Internal Ref: EXTERNAL/2024/0020

Inner West Council Response: SSD-76927247 – The Timberyards by RTL Co.

Property: Lots bound by Victoria Road, Sydenham Road, Farr Street and Mitchell Street, Marrickville NSW 2204

Figure 11 Building G – Extent of variation with the maximum height plane identified in blue
Source: Design Team

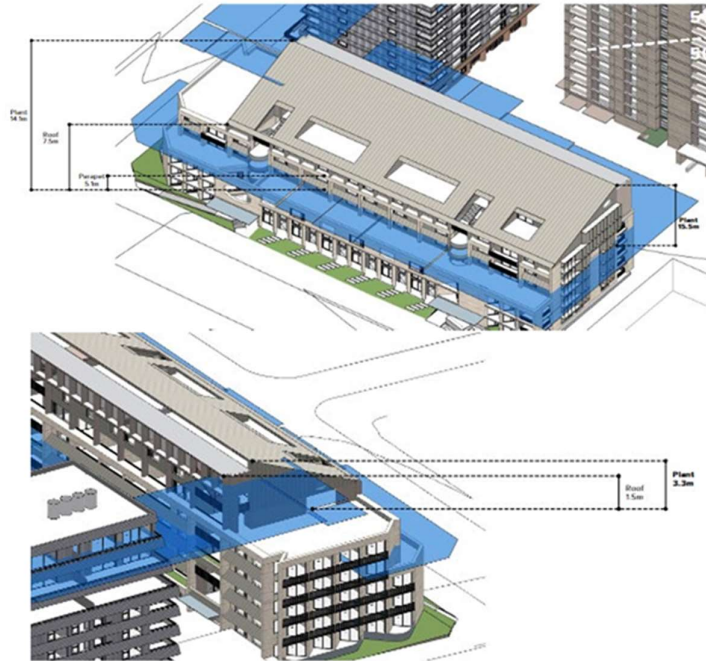
- a) The height of Building G has been reduced by 1 to 3 storeys and the upper-level setback has been increased to 9m from Farr Street. Whilst the reductions are welcomed, Building G still constitutes a 117% (15.5m) variation to the Height of building development standard.

- b) A suitable transition between Building G and the surrounding properties has not been provided. In particular, the revised 8-storey building will not provide an adequate transition to the 'corner site' which has an 11m Height of building development standard under the Inner West Local Environmental Plan 2022 (IWLEP 2022) and a 3-storey height control in Part 9.47 of the Marrickville Development Control Plan 2011. Even when the in-fill affordable housing bonus of *SEPP (Housing) 2021* is used, this would only result in a 4-storey building. The resultant transition from an 8-storey building to a 4-storey building is considered a poor outcome.

- c) The height/massing at the south-east end of Building G compromises the amenity of the existing development and any future development on the 'corner site'. Amenity impacts relate to the visual bulk and scale of Building G and additional overshadowing resulting from the variation in height. This is further discussed with regard to building separation in Part 2a) of this letter.

- d) The proposed gabled roof form adds unnecessary visual bulk, particularly when viewed from the eastern and western (side) elevations.
- e) Notwithstanding the comments raised in 2a) below recommending a greater building separation of Building G and the corner site, the upper levels above the IWLEP 2022 height plane (levels 5-8) identified in blue in Figure 11 below, should have a greater side setback to the south-east side boundary similar to that on the Sydenham Road/Farr Street corner. This would result in a centralised upper portion of the building setback from the north-west (Farr Street), south-west (Sydenham Road) and south-east (adjacent to corner site).

- f) The south-west corner of Building G has an applicable Height of building development standard of 11m. The portion of the building within this area (corner of Sydenham Road and Farr Street) should be reduced in height to provide a more suitable transition to the properties to the south-west. This would constitute a greater setback from Farr Street at level 3.

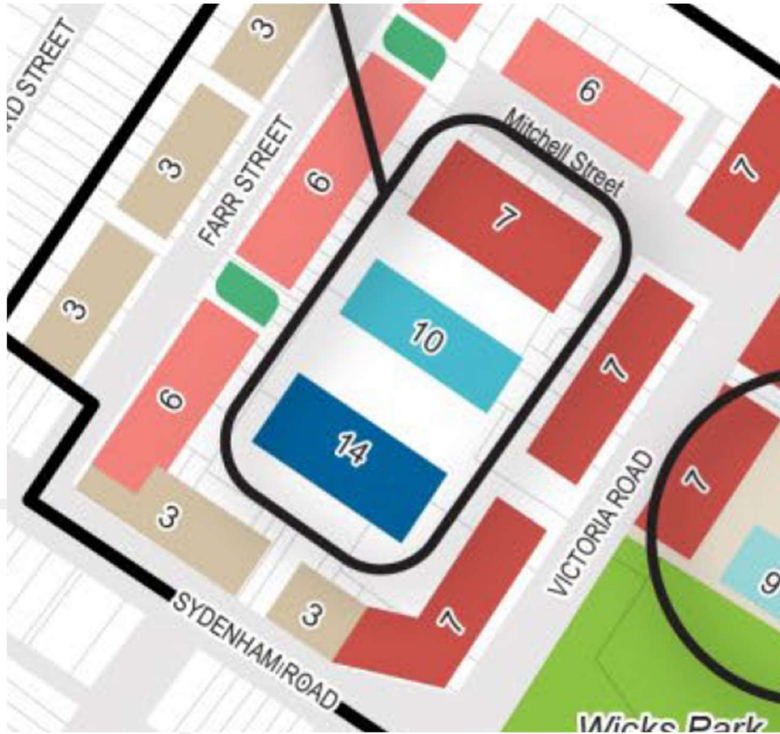
While the conceptual scheme includes detail on the dwelling mixes, communal areas, parking, services and solar access to demonstrate minimum ADG compliance, a number of concerns have arisen from the scheme which reinforces concerns raised in the previous submission. These are discussed as follows:

- a) **Building separation** - The corner site is unfairly burdened by Buildings G and D, and is required to provide more than half the building separation requirements of the ADG:

Building D proposes a 2m setback to the Corner Site. The ADG requires a minimum 6m separation between a blank wall and habitable windows. Given Building D is to the north of the Corner Site, it is therefore critical that greater building separation is provided to ensure any future development on the Corner Site can reasonably achieve the minimum solar access requirements of the ADG. As such, it is recommended that Building D be setback a minimum 6m from the Corner Site.

Building G is proposed to provide a 3m setback from the Corner Site. The ADG requires a minimum building separation of 12m from habitable window to habitable window. The conceptual scheme shows a 9m separation, of which 6m is located on the Corner Site. This is neither equitable nor in compliance with the ADG. Or it assumes that the Corner Site will only have non-habitable windows on its western elevation. Given the solar access challenges of the Corner Site created by the subject proposal, it would be highly advantageous to locate private open spaces and living areas on its western elevation, thus requiring a 12m building separation. As such, Building G should be setback a minimum 6m from the Corner Site.
